**Technical Service Bulletin (TSB)**  
**Oil Leakage From The Timing Cover**

| <b>REFERENCE:</b>         | <b>TSB:</b> 09-013-25 REV. A<br><b>GROUP:</b> 09 - Engine   | <b>Date:</b>                 | May 30, 2025 | <b>REVISION:</b> | 09-013-25 |
| <b>VEHICLES AFFECTED:</b> | <b>2020 - 2024 (GA) Alfa Romeo Giulia</b><br><b>2020 - 2024 (GU) Alfa Romeo Stelvio</b><br>This bulletin applies to vehicles built on or before May 02, 2024 (MDH 0502XX) equipped with the 2.0L 280 HP I4DI Turbo Engine (Sales Code EC2). | <b>MARKET APPLICABILITY:</b> |              |                  |           |

**Fig. 1**  
Tightening Sequence

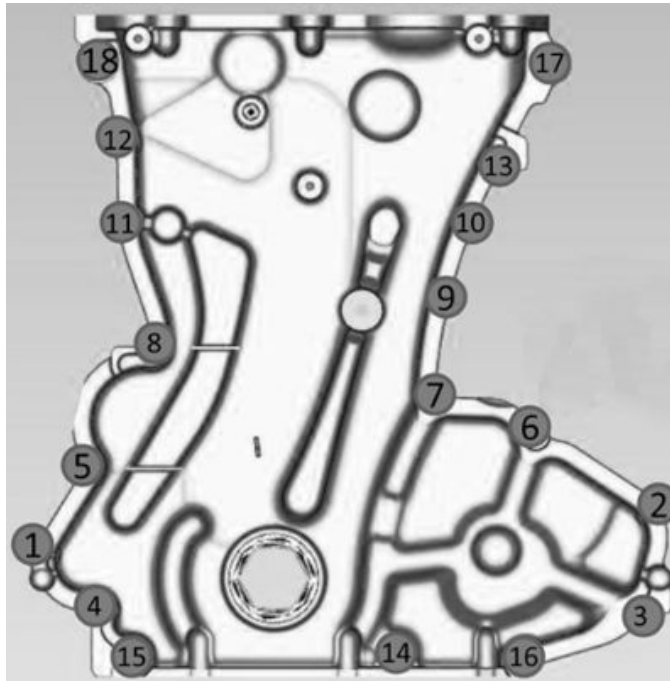
3. Using a paint pen, mark every fastener corresponding to its current rotational position. Then turn the fasteners to loosen and return it to their original position for tightening torque. The current torque must be between 8.6 Nm (6.343 ft lb) and 11.0 Nm (8.113 ft lb).

4. If the residual torque is below the 8.6 Nm (6.343 Ft lb) limit, proceed as follows:
  - Using a digital torque wrench (recommended), loosen the fasteners, tighten to a torque of 5 Nm (3.687 Ft lb) and apply another 40°. The current torque must be between 11.0 Nm (8.113 Ft lb) and 16.0 Nm (11.801 Ft lb).

- Using a digital torque wrench (recommended), apply a torque of 10.0 Nm (7.376 ft lb) using a mechanical torque wrench.

**NOTE:** Refer to the order shown in [Fig. 1](#) for tightening the fasteners.
